PROJECT DESCRIPTION:	SURVEY FOR:
MAHMOUD ABDIRAHMAN	
5743 MABLETON PARKWAY	
COUNTY: COBB	DISTRICT: 18TH
LAND LOT: 39	SECTION: 2ND
	D.B. 14535, PG. 1072
REVISIONS

APPLICANT: Mahmoud A. Abdirahman

PETITION NO.: Z-44

Z-44 (2012)
Previous Minutes

Z-44
(2012)

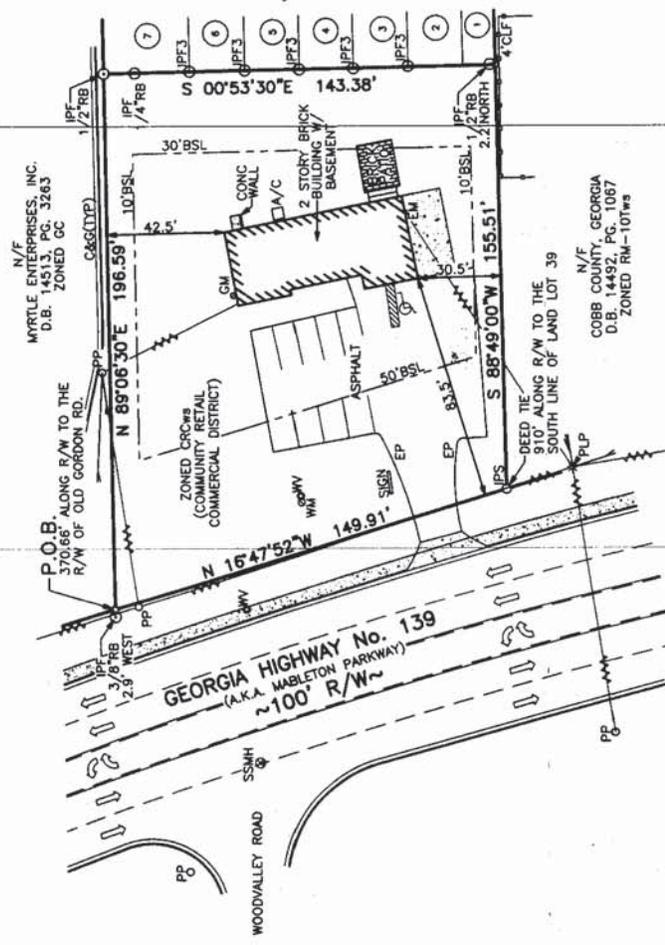
Applicant is requesting to rezone the property to the Community Retail Commercial (CRC) zoning district for the purpose of removing stipulation previously approved as part of Z-114 of 2003 that limited the use of the property specifically for a beauty parlor (minutes attached). Applicant intends to have retail and/or office tenants. No improvements are planned and the existing building will be utilized. The hours of operation for the businesses will be Monday – Saturday from 8 a.m. until 6 p.m.

Size / Location of Existing Water Main(s): **12" DI E / side of Mableton Parkway**

Approximate Distance to Nearest Sewer: **In Mableton Parkway ROW**

Additional Comments: Health Dept approval required for continued use of existing septic system. If improvements to septic system are necessary, site must connect to sanitary sewer

No site improvements are proposed for this existing facility, therefore no stormwater management measures will be required at this time. Any future improvements must be submitted to Plan Review and subject to current Stormwater Management requirements.

Recommend GDOT permits for all work that encroaches upon State right-of-way.

Recommend reconstructing the driveway to meet the commercial standard.

- Site plan received by the Zoning Division on August 16, with the District Commissioner approving minor modifications;
- Continue to meet parking standards of one space per 200 net square feet of retail space or one space per 285 net square feet of office space;
- Water and Sewer comments and recommendations;
- Stormwater Management Division comments and recommendations; and
- DOT comments and recommendations.
